Arlington Conservation Commission

Agenda

On behalf of the Arlington Land Trust ("ALT"), I have attached two comment letters concerning the Request for Superseding Order of Conditions filed by Arlington Land Realty LLC concerning the proposed Thorndike Place development (the "Project") located off of Dorothy Road in Arlington, Massachusetts.

**RE: Thorndike Place, Dorothy Road, Arlington, Massachusetts – Summary of Key Issues
in Response to BSC Letter Dated June 10, 2024**

Figure 1 – Location of model boundary features represented in MMA’s numerical model mounding analysis.

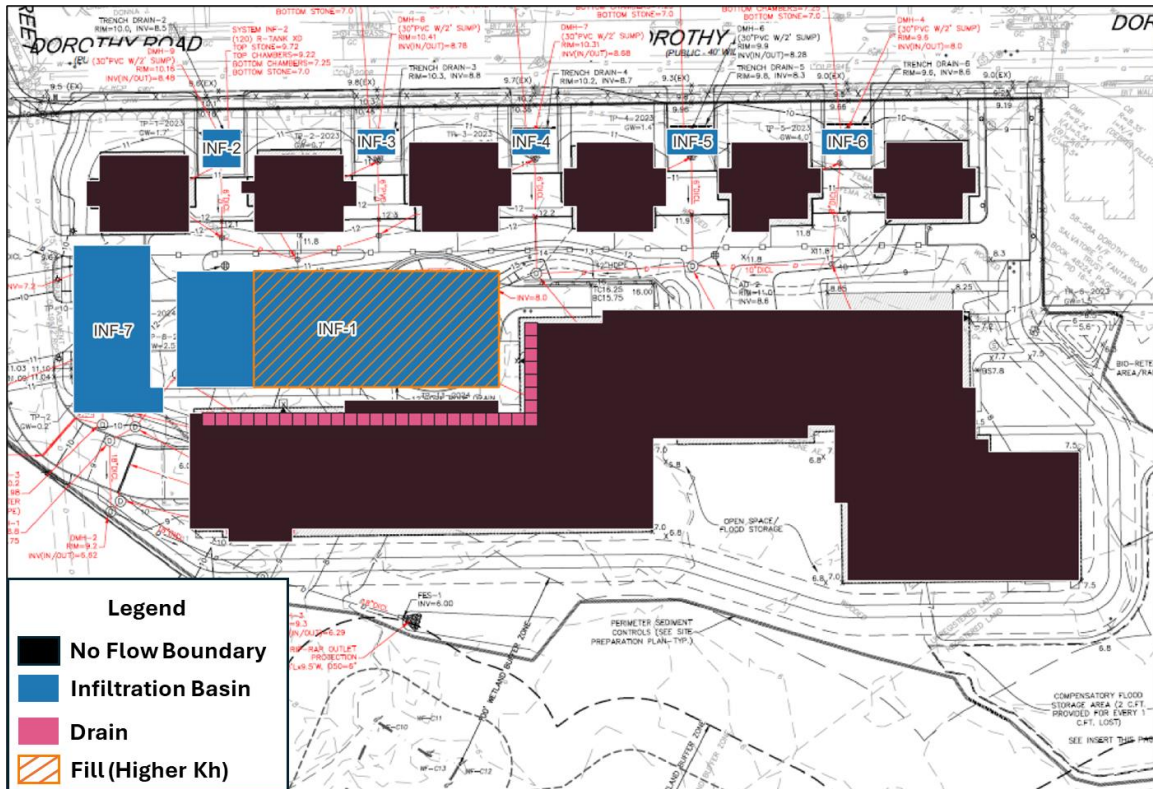
In scenarios 2 and 3, additional model layers were added, and the regions of the model domain coinciding with the foundations of the townhomes and the main building/main building parking garage were inactivated (i.e., MODFLOW IBOUND array values set to 0). This action establishes no-flow boundaries along the perimeters and bases of the foundations, so groundwater cannot flow horizontally or vertically through those areas.

Figure 4 – Comparison of the MODFLOW and Hantush analytical models

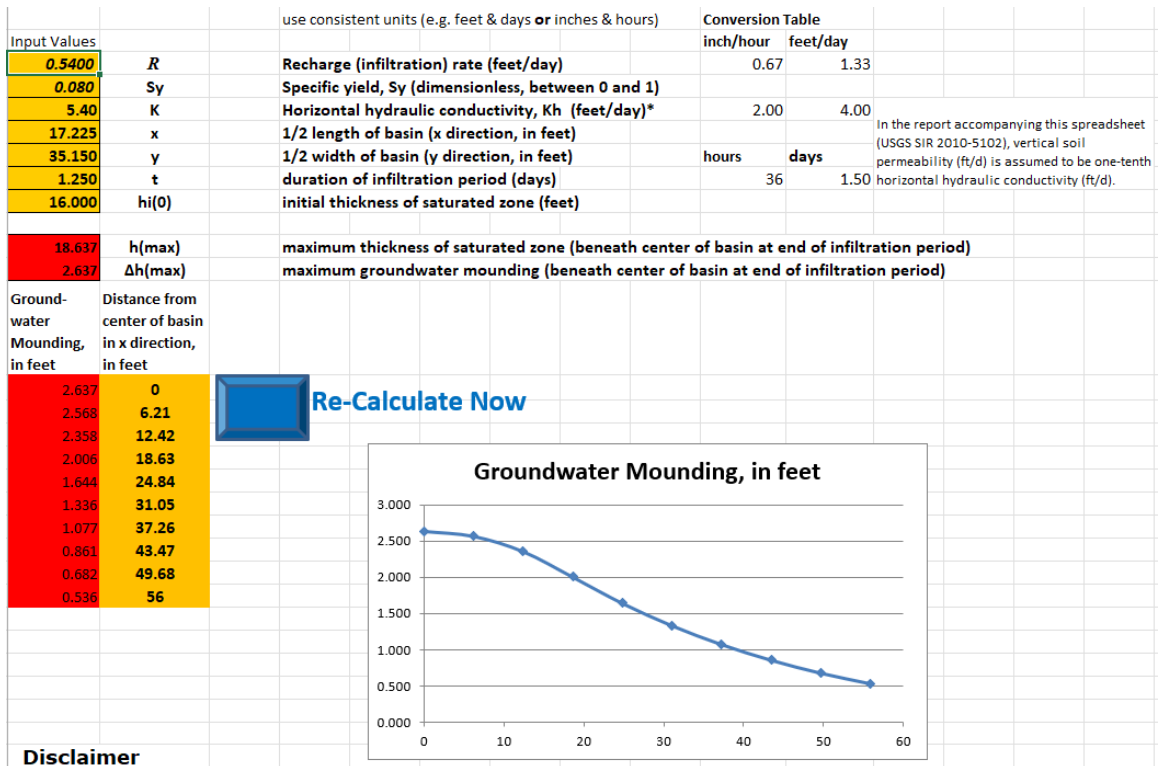
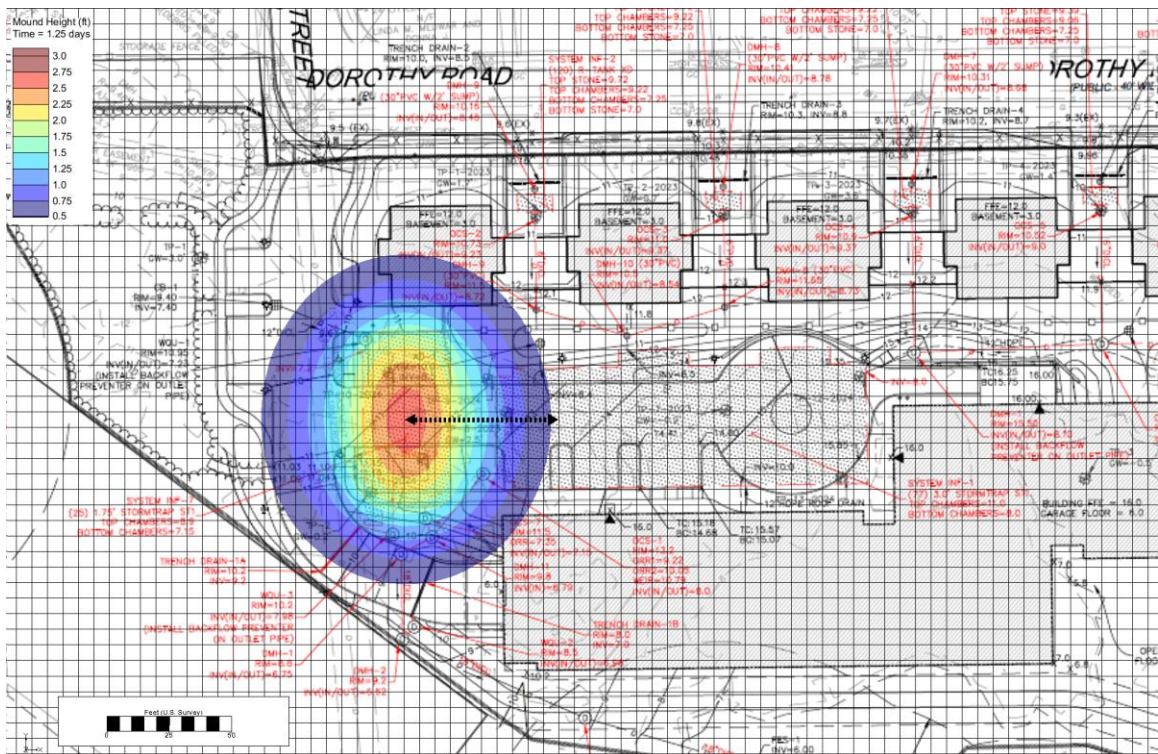
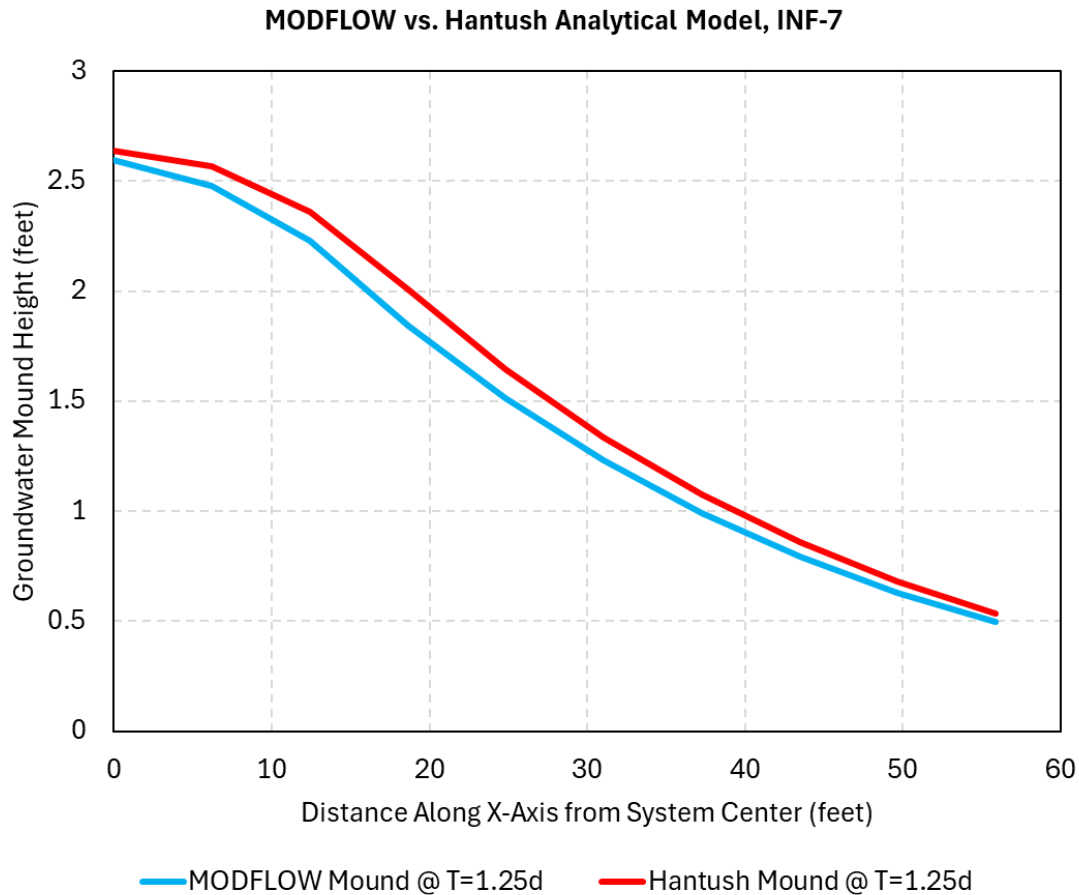
Figure 4, below, directly compares the mounding height predictions from the two models along the represented—or selected, in the case of the MODFLOW model (see the dashed black line in **Figure 3**)—transect.

As **Figure 4** shows, the two models produce very similar results, with MODFLOW generating mounding height predictions that are slightly lower than the Hantush analytical model. In terms of peak mounding height, this outcome is consistent with results produced by a separate study led by the U.S. Geological Survey that directly compared the Hantush analytical model and MODFLOW⁹. **Thus, the results of the Scenario 1 simulation demonstrate the MODFLOW model can be reliably applied as an extension of the Applicant’s analysis to address MMA’s stated objectives, which are to illustrate certain deficiencies in BSC’s mounding analysis approach and assess GZA’s recommended mitigation measures.**

Figure 5 – Simulated maximum groundwater heads within each infiltration basin under Scenario 2 conditions, along with the bottom elevation of the infiltration system.

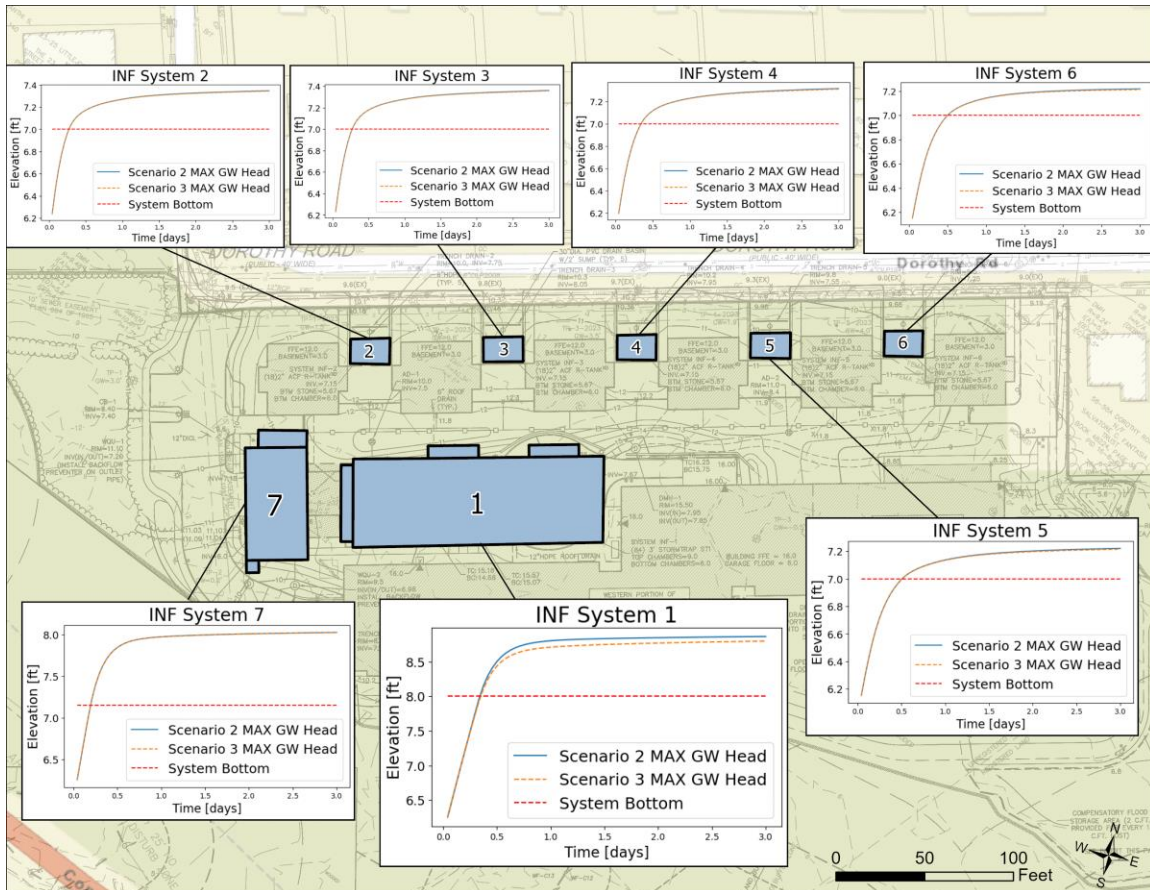
As indicated by **Figure 5**, the simulated water table rises to and exceeds BSC's claimed system bottom elevations for all seven proposed infiltration systems, after approximately less than 12 hours of active infiltration. Modeled heads display asymptotic conditions as a result of the head-dependent (i.e., RIV package) representation of infiltration, which causes infiltration rates to decrease after simulated heads exceed system bottom elevations. In other words, infiltration rates are being reduced due to severe groundwater mounding below the systems, and groundwater levels/potentials at the systems stop rising. As noted previously, this is an approximation of the magnitude of rate decrease, but **the model's prediction of critical concern—that differs drastically**

2. As shown in Scenario 2, if the Applicant's analysis considered additive effects from multiple, simultaneously active systems and lateral interference from building foundations, it would show mounding rising above proposed system bottoms. That prediction would violate BSC's own claimed design objectives, and it would invalidate the key assumption relied upon in BSC's HydroCAD modeling and system drainage time calculations (i.e., use of constant, unimpacted exfiltration/infiltration rates), thus rendering calculations based on that assumption unreliable.

Figure 6 – Simulated maximum groundwater heads within INF-1 under Scenario 3 conditions along with the bottom elevation of the infiltration system.

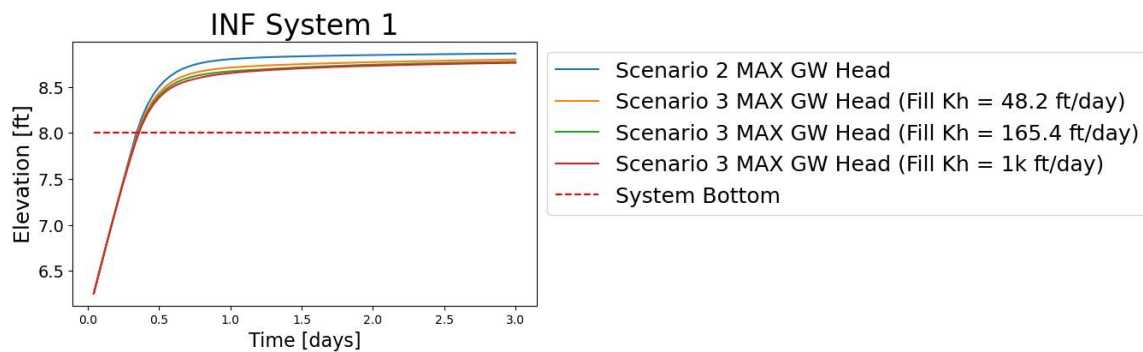
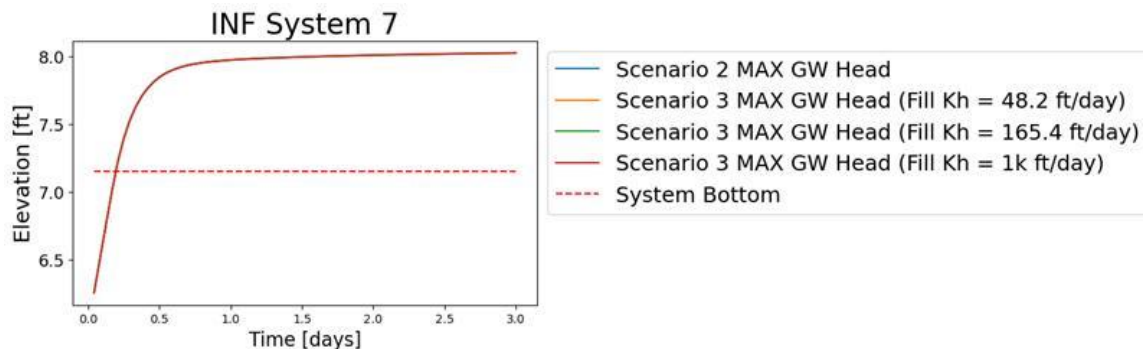
The purpose of the Scenario 3 simulation is to assess the impact(s) of GZA's suggested mitigation measures. **Figures 6 and 7**, below, provide time series of simulated heads for INF-1 and INF-7 under Scenario 3 conditions that are comparable to the plots shown in **Figure 5**.

As indicated by **Figure 6 and 7**, the **Scenario 3 simulations suggest GZA's proposed mitigation measures would be generally ineffective, particularly with respect to preventing groundwater mounding from rising to and above the bottom of INF-7**. (Note that the Scenario 3 results reflect only adjustments/increases to hydraulic conductivity values within the assumed peat excavation area. INF-1 infiltration rates in this area were not adjusted because the Applicant has not provided information supporting infiltration rate assumptions for the fill area and an associated updated HydroCAD analysis. Updated Scenario 3 simulations can be performed by MMA should appropriate new information be made available. However, based on currently available information, MMA believes the current simulations are conservative, as an increased infiltration rate would presumably exacerbate mounding and potentially accelerate the timing of heads arriving at system bottom elevations.)

Infiltration Duration (100-year, 24-hour storm) – 40.5 hours (approx.):

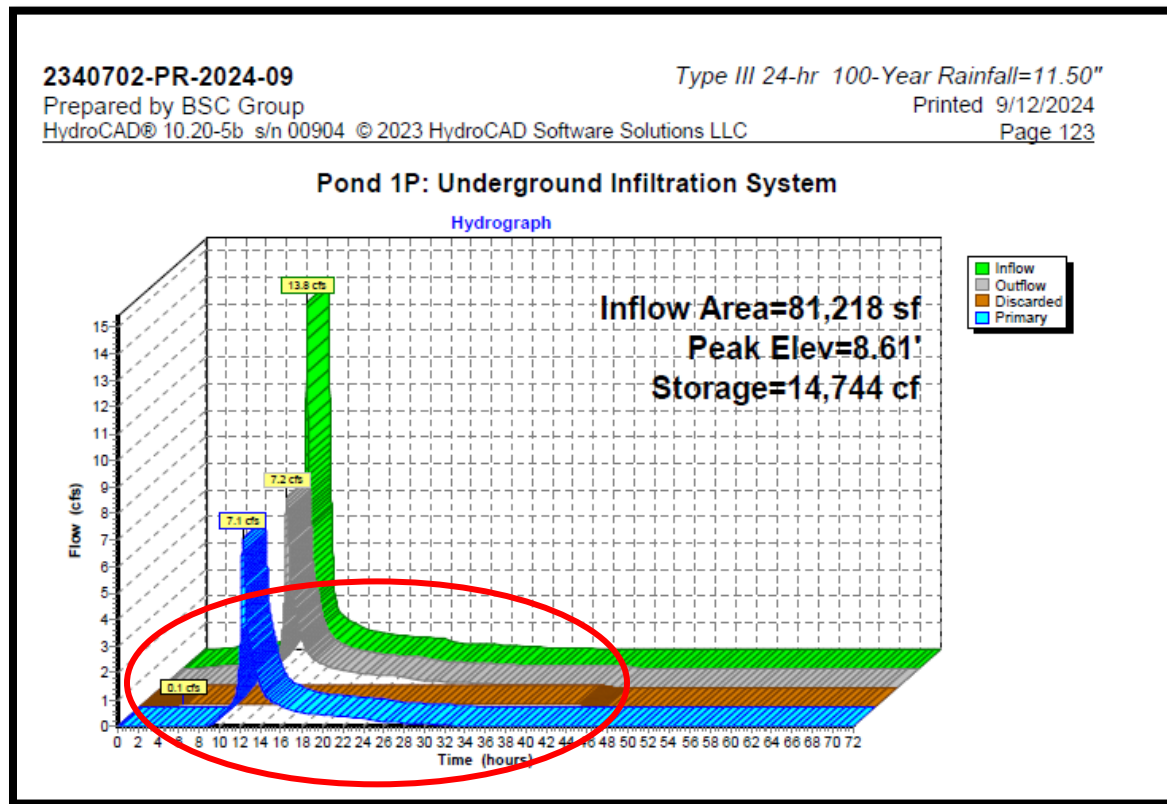
Note: the predicted duration of infiltration is illustrated by the slightly raised portion of the burnt orange “Discarded” time series, which extends from approximately hour 4 through hour 44.5 of the 72-hour simulation period.

The result presented above indicates BSC’s assumed infiltration rate is a factor of two higher than the maximum applicable rate of 0.27 inches/hour listed in the MSH. Thus, BSC’s HydroCAD model is overstating the ability of the proposed system to infiltrate stormwater. Notably, GZA identified a similar discrepancy when reviewing BSC’s revised groundwater mounding and drainage time calculations; however, their recognition of the issue did not appear to extend to BSC’s HydroCAD simulations.

Figure 1 - Groundwater Mounding at Stormwater Infiltration System (Steady-State Conditions)

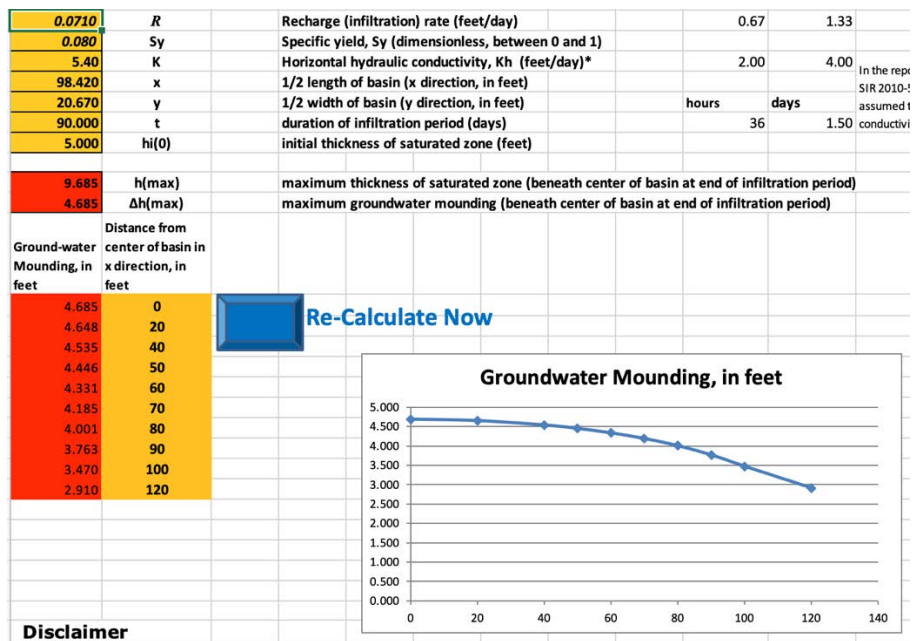
To evaluate the impacts of this concentrated infiltration system I have prepared an updated groundwater mounding analysis to determine the cumulative impacts of smaller storms throughout a 90-day period¹. I have utilized the input data for hydraulic conductivity, specific yield and saturated thickness directly from BSC's Response to GZA Peer Review dated October 4, 2024 (Attachment E). I have applied a cumulative runoff rate of 40 inches/year (or 10 inches for the 90-day period)². This analysis shows that the proposed infiltration system will be inundated with a groundwater mound of approximately 4.6 feet and will be unable to function as proposed (see Figure 1).

In summary, the post-development groundwater mounding associated with cumulative recharge associated with smaller storms will raise groundwater levels throughout the site. Utilizing the Hantush modeling inputs provided by BSC these conditions will cause water level increases of several feet at the wetland boundary. MADEP commonly applies a guideline of 0.1 feet as a maximum acceptable alteration in wetlands.

Figure 2 - Hydrograph for USGS Lexington Index Well (March - April 2024)

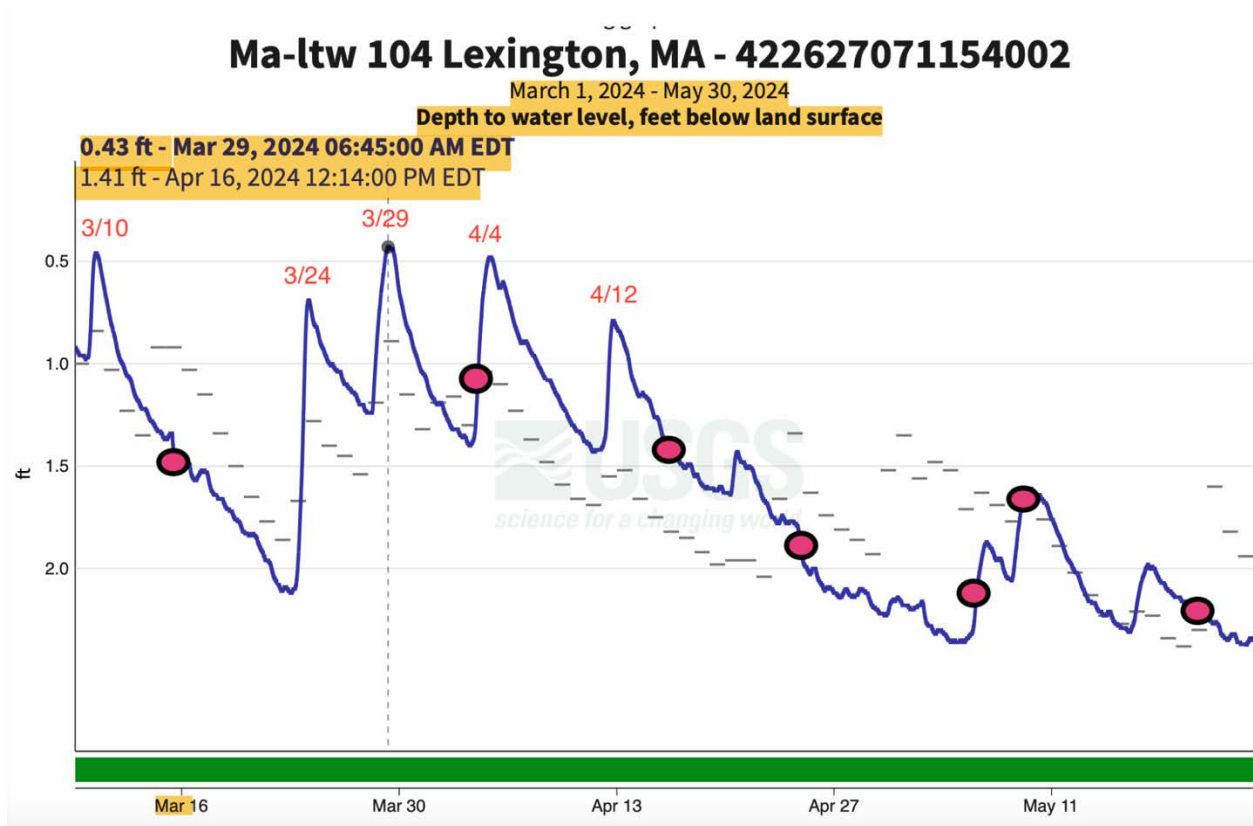
Figure 2 shows a comparison of water levels measured in a well installed by BSC at the location of TP-9 (red dots) with the USGS Lexington well hydrograph during the 2024 spring period. This comparison shows that BSC water level measurements were reported on dates that missed all of the peak levels recorded at the USGS well during the Spring 2024 period. The highest groundwater levels were observed at the USGS well on March 24, 29, and April 4. Had BSC used a continuous recorder (as I recommended in my earlier comment letters) they would have likely recorded higher levels, consistent with the USGS well).

Figure 3 - Hydrograph for Arlington Land Trust (ALT) Monitoring Wells at Dorothy Road (March - April 2024)

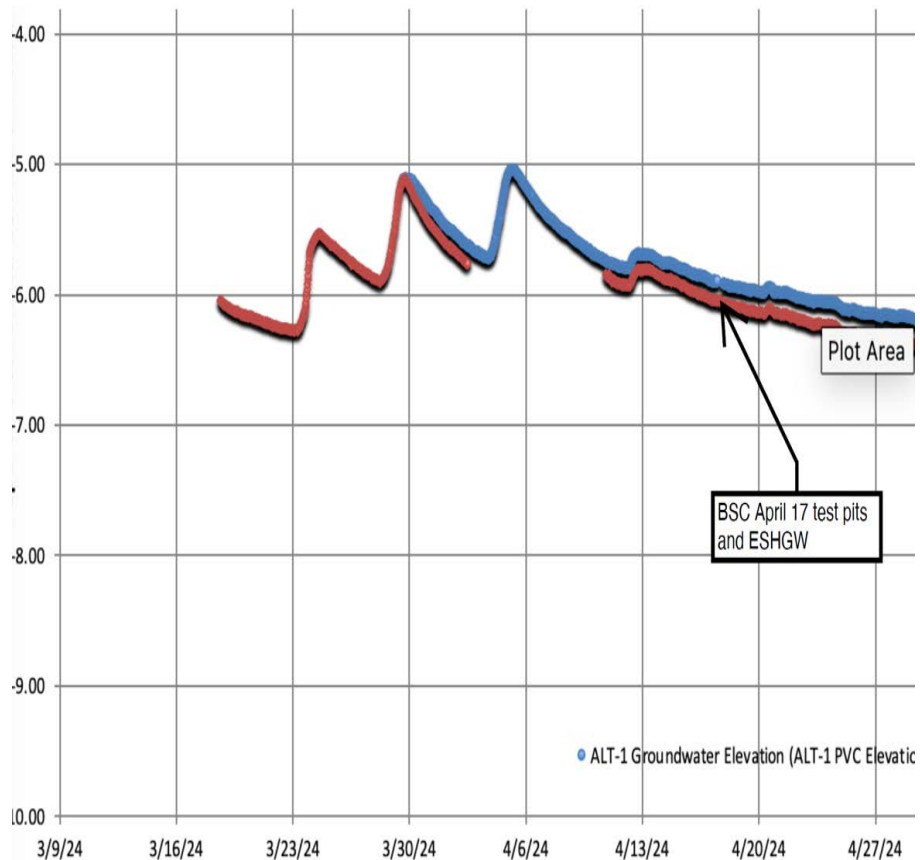
This same variance in groundwater levels is further corroborated with our own water level measurements at the Arlington Land Trust well located on Dorothy Road which showed a peak elevation on March 29, 2024 and a similar decline throughout much of April to a level of approximately 1-foot lower on April 17 when the test pits were excavated (see figure 3). This suggests that the relative groundwater level fluctuations over this period are consistent with the USGS Lexington well (which showed a 1-foot decline during this same period).
